Project Name: Duke Street Mill

Initial Fire Strategy Comments

Date: 24/05/2024

File name: SKT-1923487-04-MS-202024
05 24-Fire Strategy Comments-Rev00

Proposed Ground Floor Plan

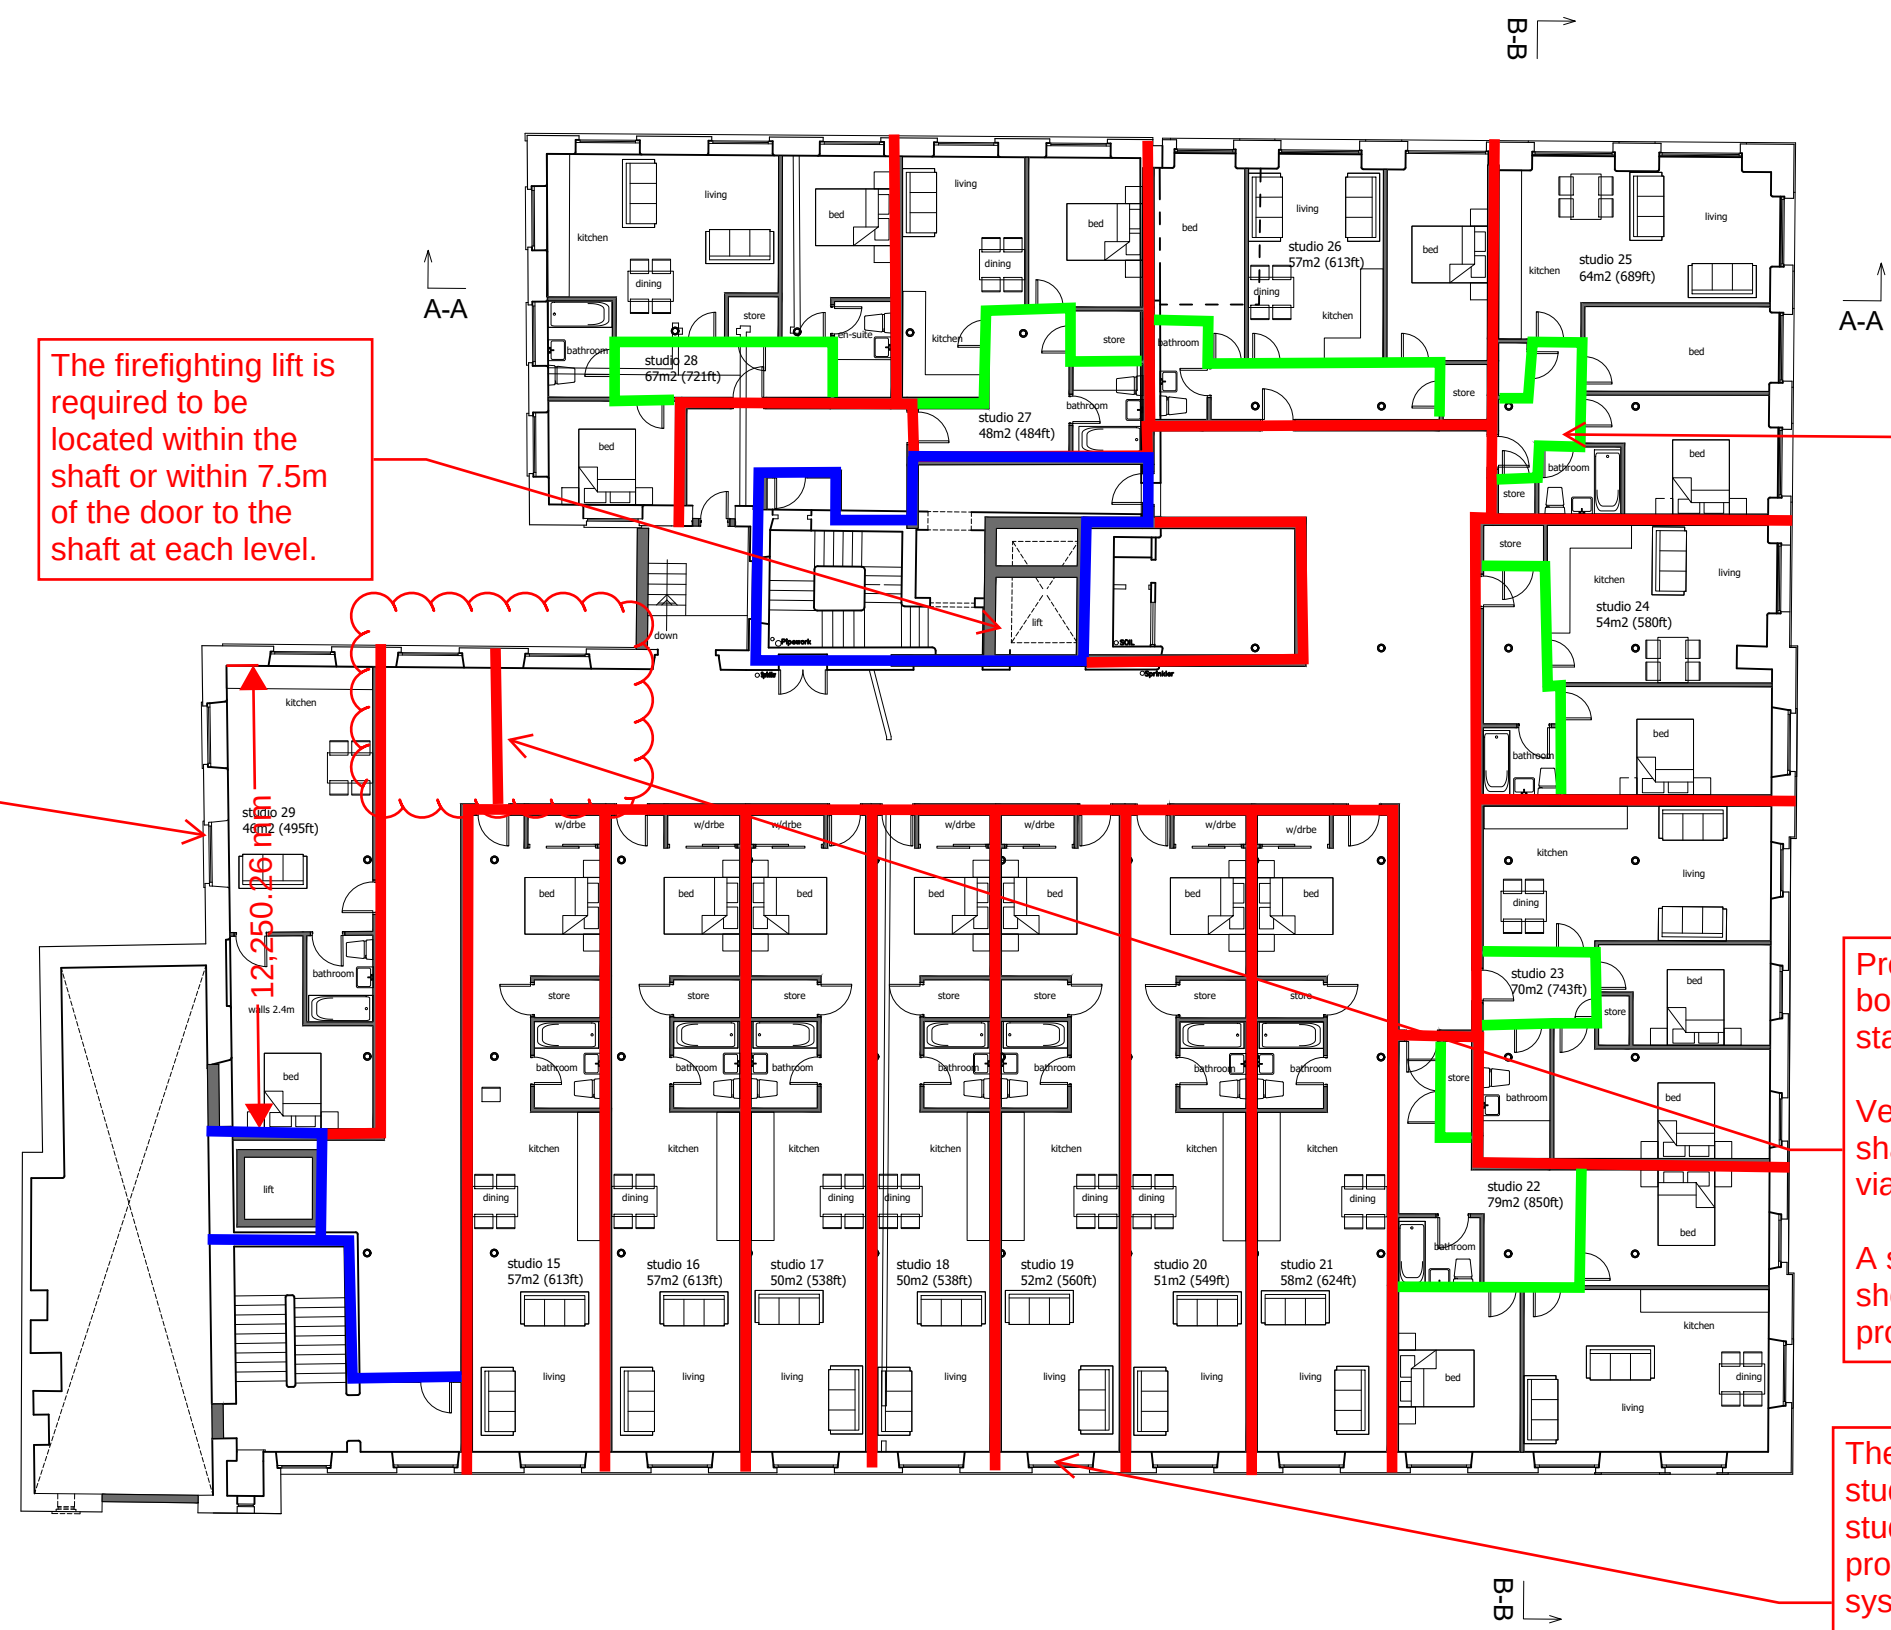
Apartments with a protected entrance hall are required to be provided with a Category LD3 alarm system.

Provide corridor sub-division and ventilate both sides of the corridor accessing each stair.

Ventilation can be provided via a smoke shaft (natural - 1.5m² or mechanical) or via a 1.5m² AOV to outside.

Please confirm use of this space - store cupboards are not permitted in a firefighting stair.

The travel distance from any point in the studio flats should not exceed 20m where the studio is provided with both sprinkler protection and a Category LD1 detection system.

Cooking facilities should be sited away from the flat entrance door and internal escape route.

Open plan apartments should not be greater than 8m x 4m where the kitchen is unenclosed. Therefore, this arrangement may require CFD analysis.

The firefighting lift is required to be located within the shaft or within 7.5m of the door to the shaft at each level.

Apartments with a protected entrance hall are required to be provided with a Category LD3 alarm system.

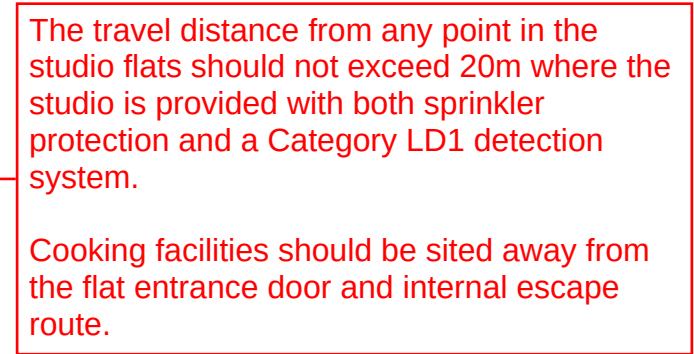
Provide corridor sub-division and ventilate both sides of the corridor accessing each stair.

Ventilation can be provided via a smoke shaft (natural - 1.5m² or mechanical) or via a 1.5m² AOV to outside.

A suggested location for corridor split is shown - with each of the windows to be provided as AOVs to external air.

The travel distance from any point in the studio flats should not exceed 20m where the studio is provided with both sprinkler protection and a Category LD1 detection system.

Cooking facilities should be sited away from the flat entrance door and internal escape route.

Apartments with a protected entrance hall are required to be provided with a Category LD3 alarm system.

Provide corridor sub-division and ventilate both sides of the corridor accessing each stair.

Ventilation can be provided via a smoke shaft (natural - 1.5m² or mechanical) or via a 1.5m² AOV to outside.

A suggested location for corridor split is shown - with each of the windows to be provided as AOVs to external air.

The travel distance from any point in the studio flats should not exceed 20m where the studio is provided with both sprinkler protection and a Category LD1 detection system.

Cooking facilities should be sited away from the flat entrance door and internal escape route.

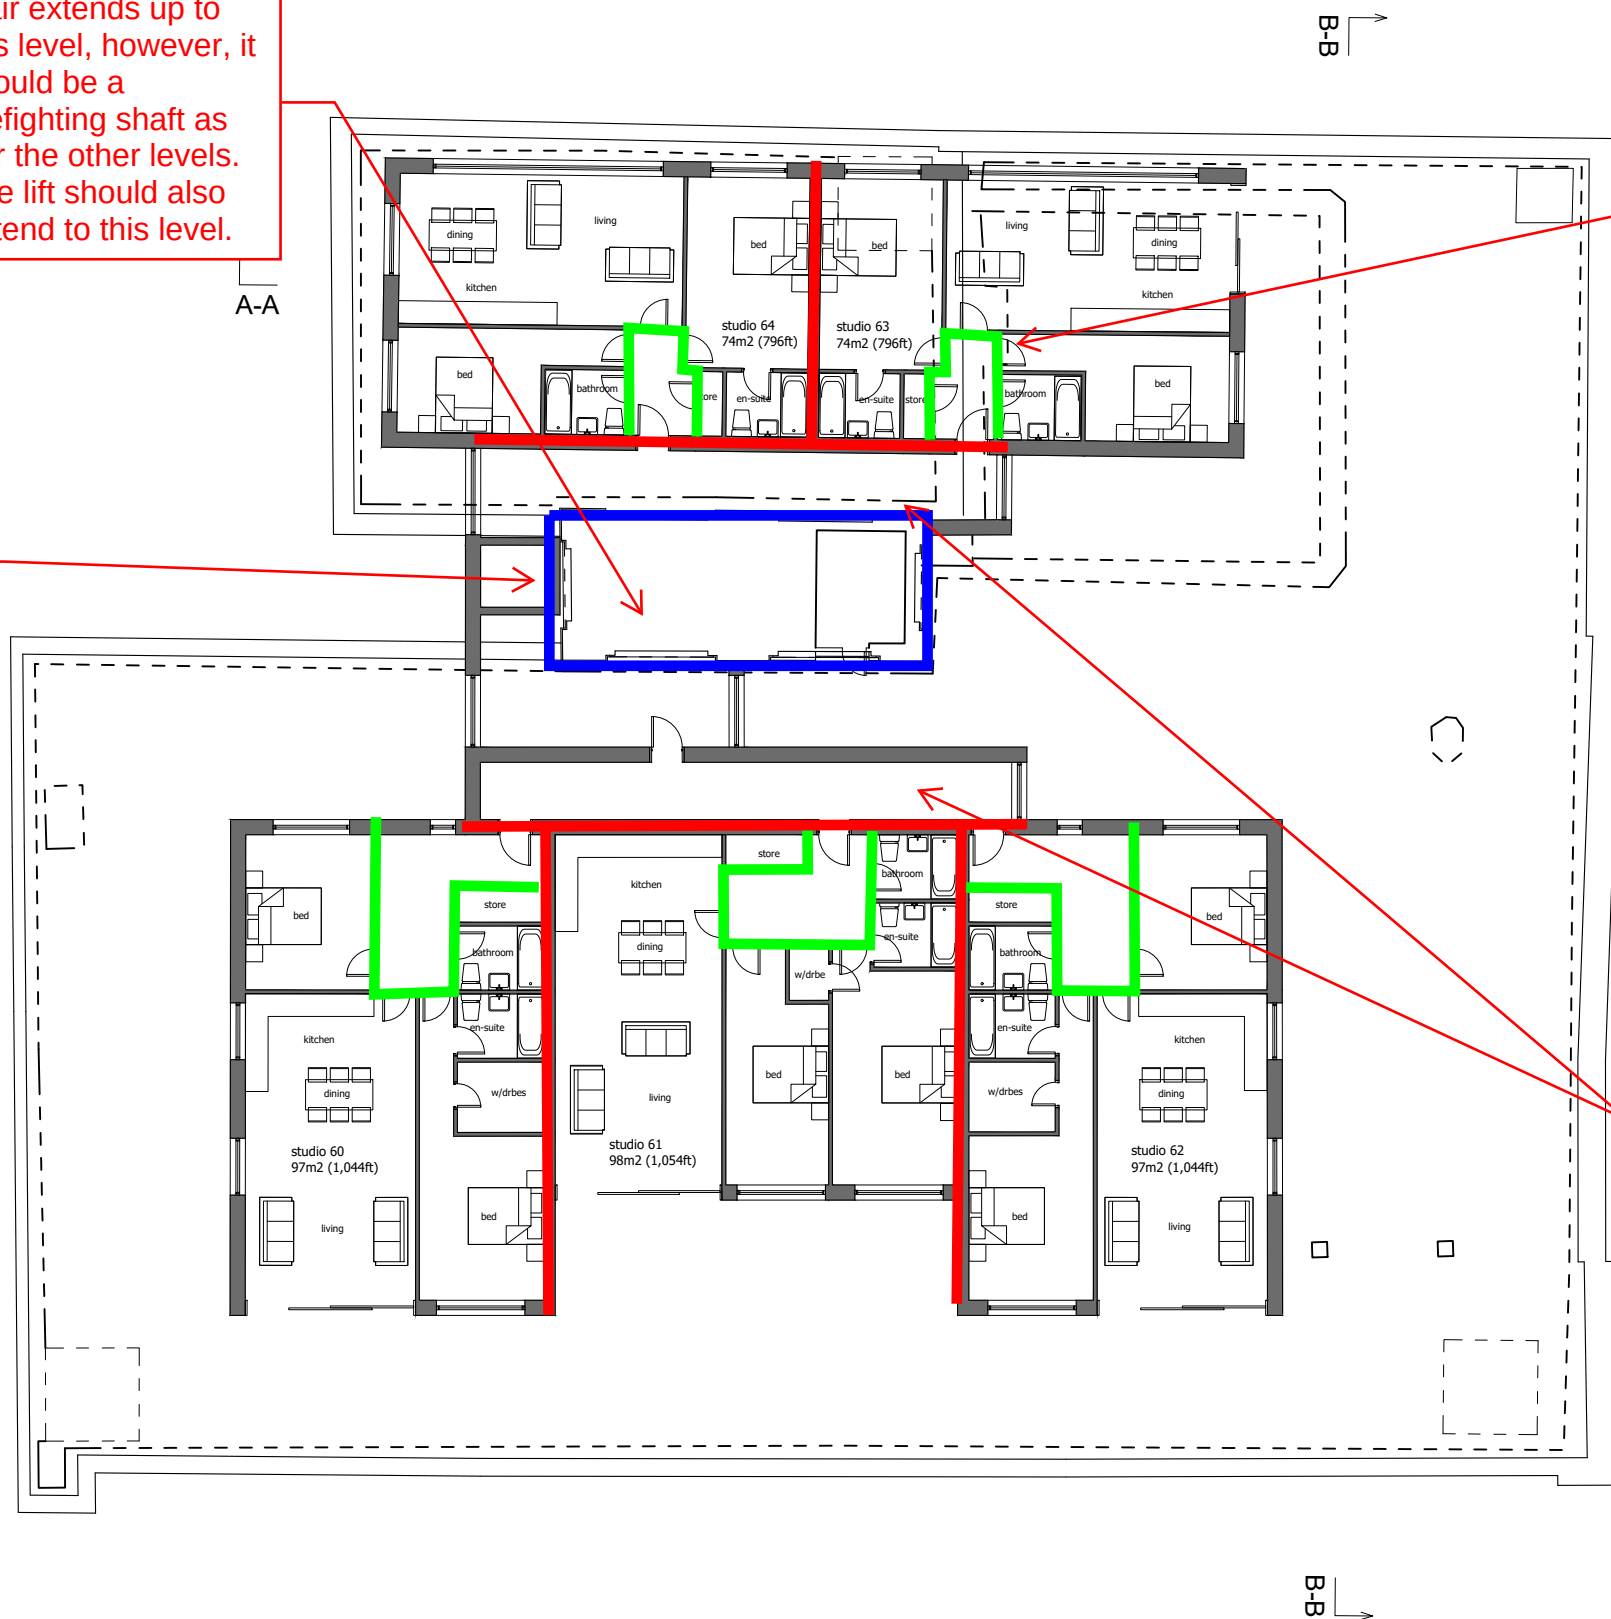
Single stair above 18m will no longer be permitted in design after 30th September 2026. If initial notice is given or a building control approval application submitted before this date, and building work has started (and sufficiently progressed) within 18 months of that date, the single stair is permitted.

It is not clear how the stair extends up to this level, however, it should be a firefighting shaft as per the other levels. The lift should also extend to this level.

Apartments with a protected entrance hall are required to be provided with a Category LD3 alarm system.

Ventilation is required in both sections of corridor at this level.
Ventilation can be provided via a smoke shaft (natural - 1.5m2 or mechanical) or via a 1.5m2 AOV to outside.

Proposed Fifth Floor Plan

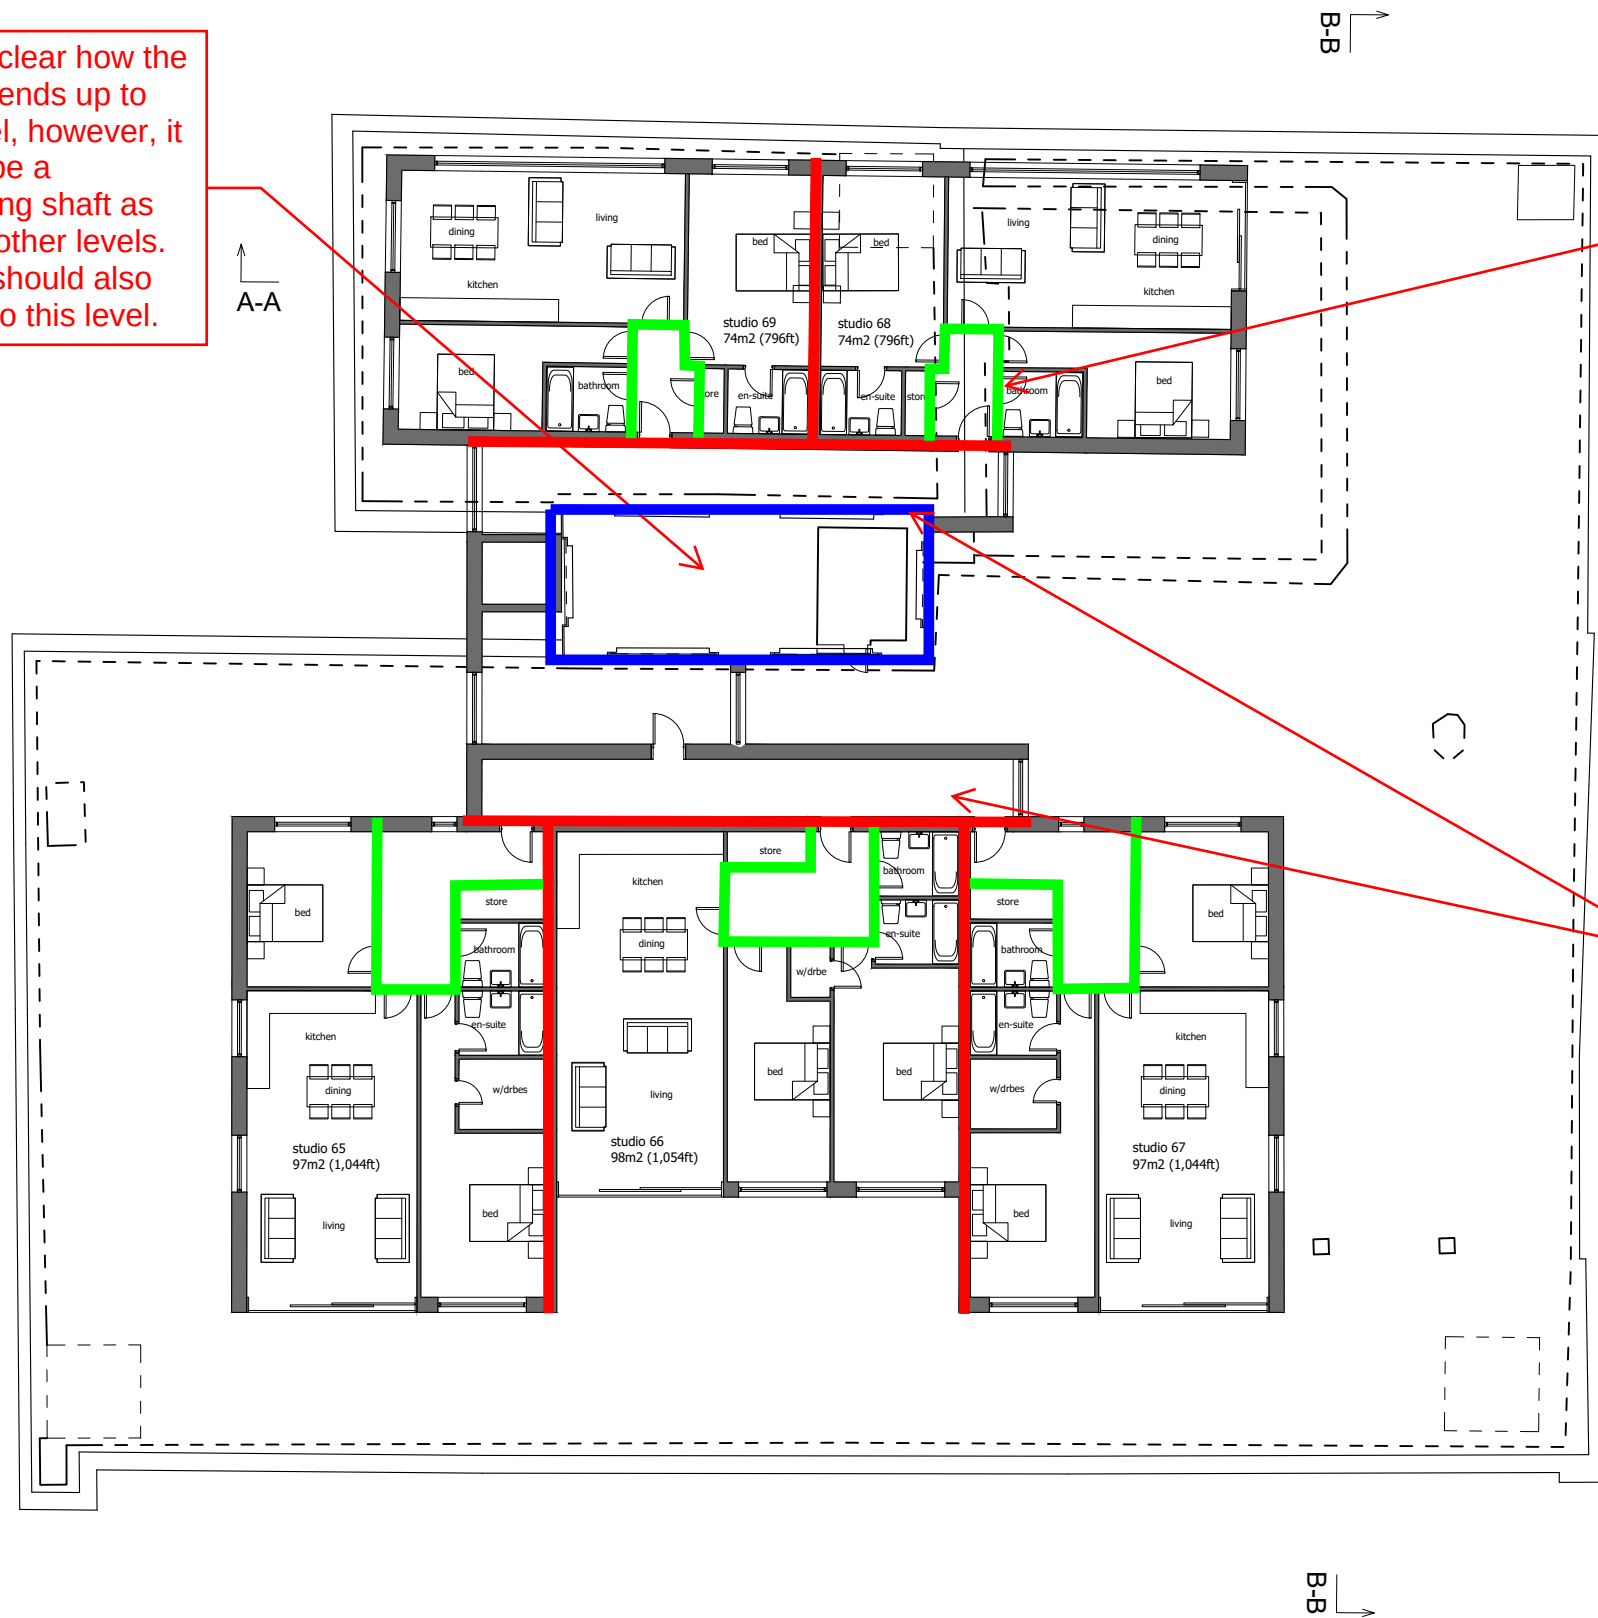
It is not clear how the stair extends up to this level, however, it should be a firefighting shaft as per the other levels. The lift should also extend to this level.

Apartments with a protected entrance hall are required to be provided with a Category LD3 alarm system.

Ventilation is required in both sections of corridor at this level.

Ventilation can be provided via a smoke shaft (natural - 1.5m² or mechanical) or via a 1.5m² AOV to outside.
